**Date:** November 16, 2018  
**To:** Eilbret Mirzapour, City of San Jose  
**From:** Robert Del Rio, T.E.  
**Subject:** 270 West Santa Clara Street Hotel Development Traffic Operations Analysis

Subject: Almaden Corner Hotel Valet Area Analysis

We have completed the review of the Local Transportation Analysis for the subject project. The project consists of a 330-room hotel with no on-site parking. The proposed project is located at northeast corner of North Almaden Boulevard and West Santa Clara Street. The proposed project is projected to add 129 a.m. peak hour trips and 165 p.m. peak hour trips.

**Figure 4**  
**Ground-Level Site Plan and Project Trips at Valet Drop-off/Pick-up Area**

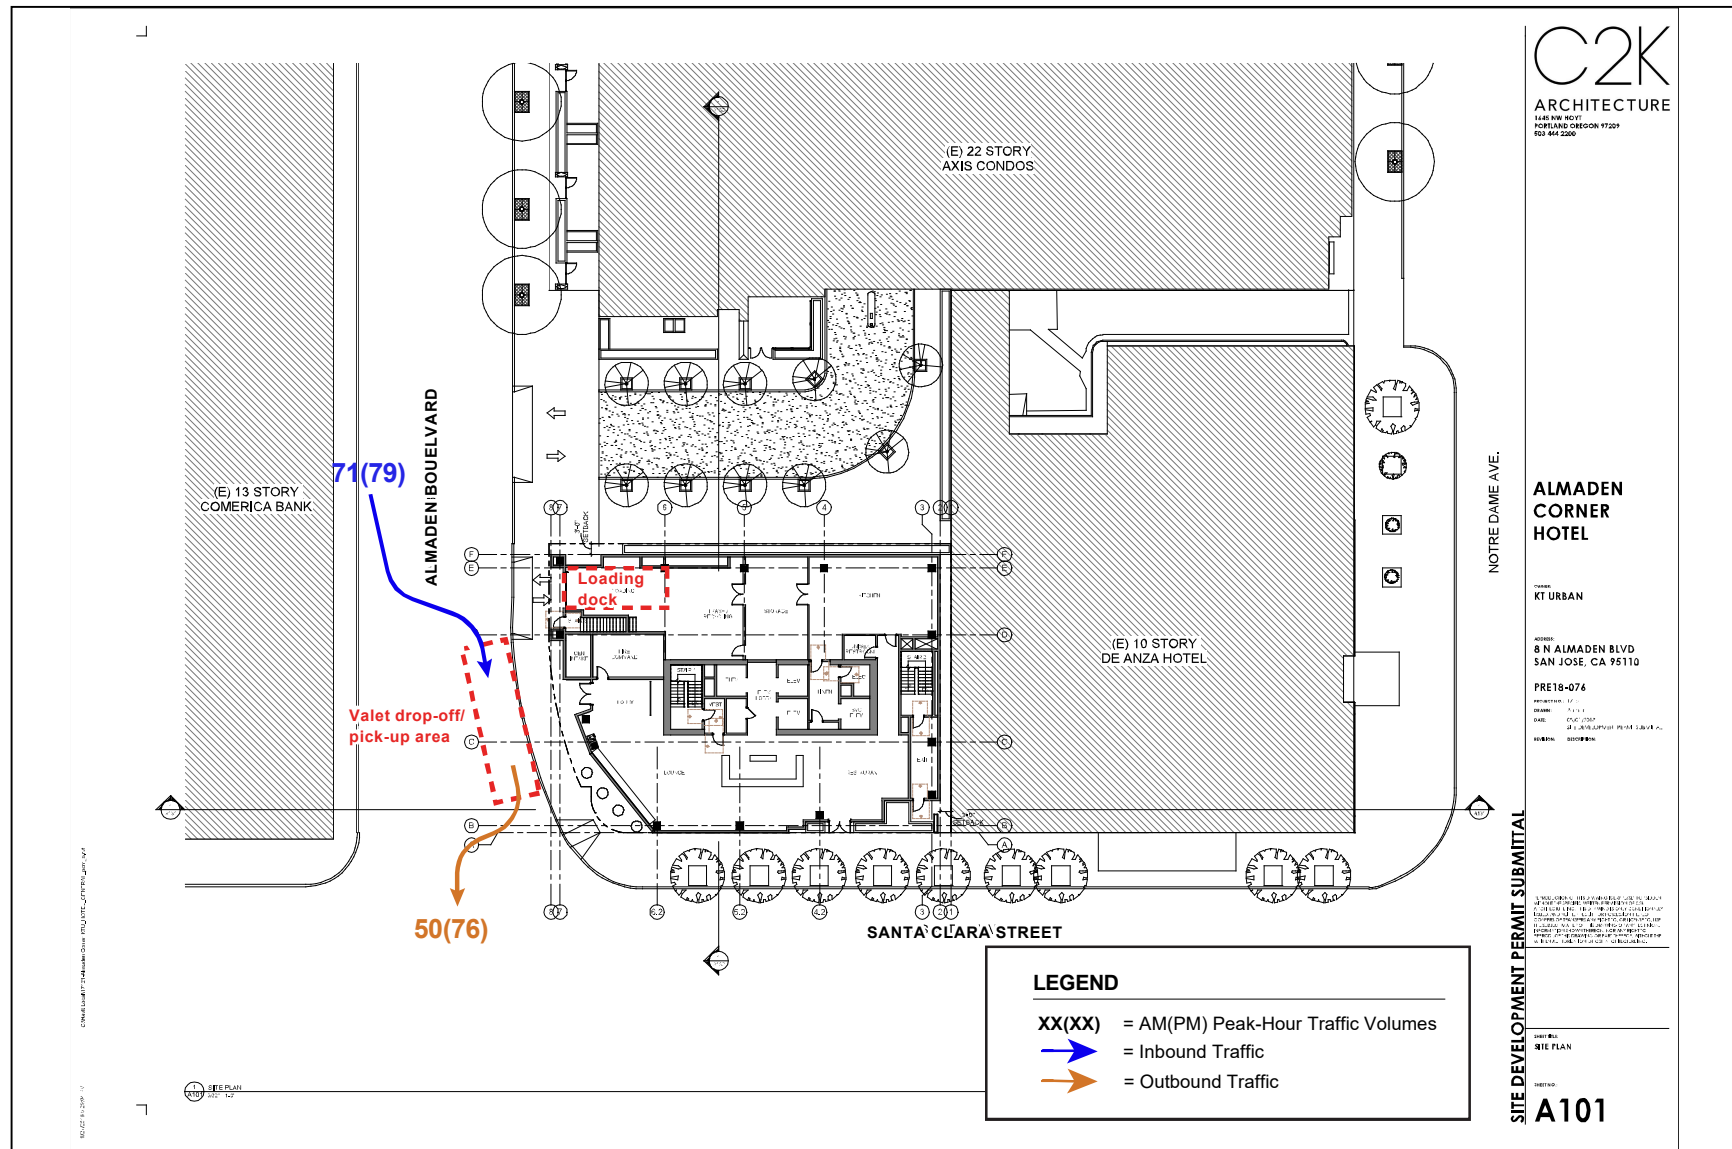
An on-street valet drop-off/pick-up zone is proposed to be located along the Almaden Boulevard project frontage. Access to the valet drop-off/pick-up zone will be constrained due to the one-way operations of streets that provide access to the project site. Inbound traffic from the south will utilize northbound-only Notre Dame Avenue and Carlisle Street to access Almaden Boulevard; from the north, inbound traffic will utilize W. St. John Street to access Almaden Boulevard.

The only outbound route from the valet drop-off/pick-up zone is via a southbound left-turn lane on Almaden Boulevard out to eastbound Santa Clara Street. An existing buffered bike lane that extends approximately 75 feet back from the Almaden Boulevard/Santa Clara Street intersection restricts project traffic from accessing the southbound right-turn lane. However, the bike lane buffer consists of only pavement markings and no physical barriers exist to prevent drivers from crossing over the bike lane.

Based on the estimated trip generation, a maximum of 84 inbound trips would need to be served at the valet drop-off/pick-up zone during the PM peak-hour, or approximately three vehicles every two minutes. The number of vehicles that can be served at the valet drop-off/pick-up zone will depend on the proposed valet parking operations. However, it is recommended that a minimum of three to four valet staff be present during the peak arrival/departure periods for the hotel. In addition, vehicles should not be retrieved in advance of guests being present at the valet area. Given the limited storage space for valet operations along Almaden Boulevard, the valet area should not be used for transportation network companies (TMCs) such as Uber, Lyft, etc. while waiting for customers. The project trip assignment at the proposed valet drop-off/pick-up zone is shown in Figure 4.

**Recommendation:** It is recommended that lane delineators be installed at the bike lane buffer to ensure that project traffic does not cross the bike lane to access the southbound right-turn lane.

Figure 1: Proposed Site Plan

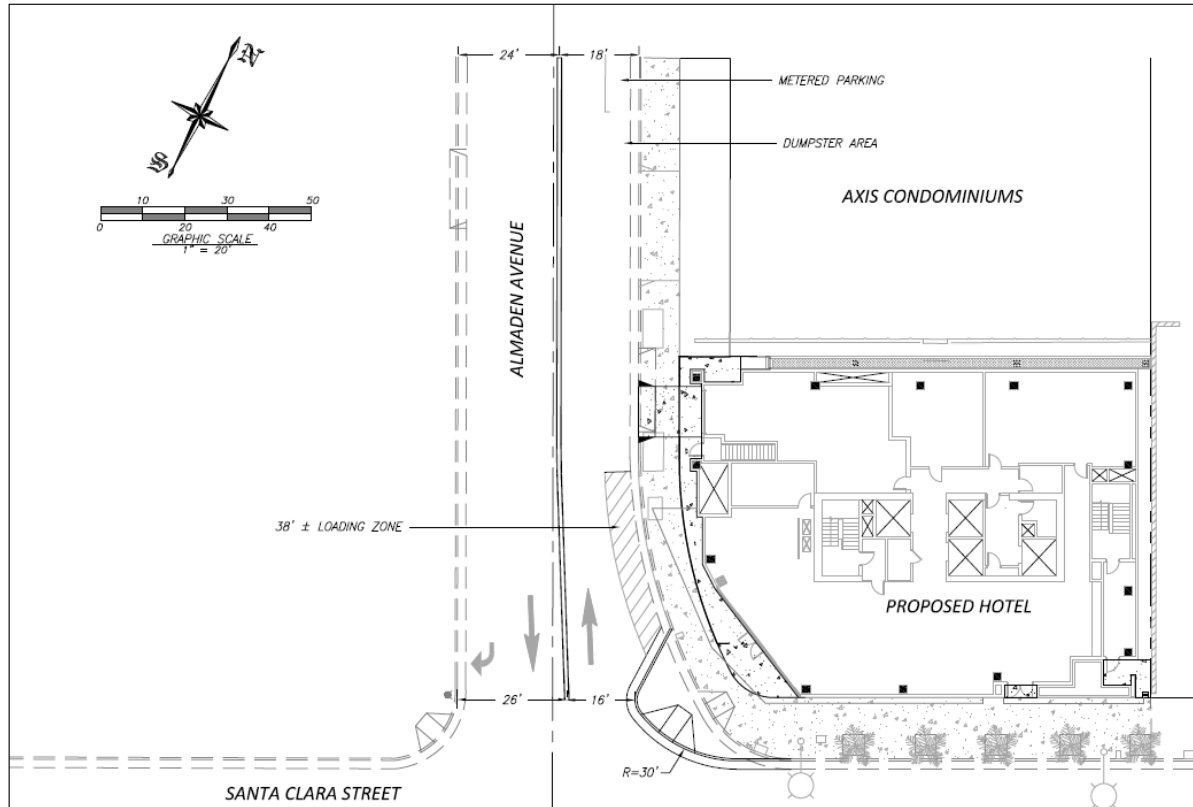
Figure 1 shows the site plan for the proposed hotel (dated March 2019). The City plans to provide a bulbout on the north-east corner to shorten the crosswalk distance on the northern leg. Two valet spaces can be provided along the hotel frontage on Almaden Avenue. The City of San Jose will also allow valet to operate on Santa Clara Street along the project frontage. Santa Clara Street will provide approximately three (3) additional valet spaces for a total of five (5) valet spaces. **Attachment A** provides a drawing with the proposed valet on Almaden Avenue and Santa Clara Street.
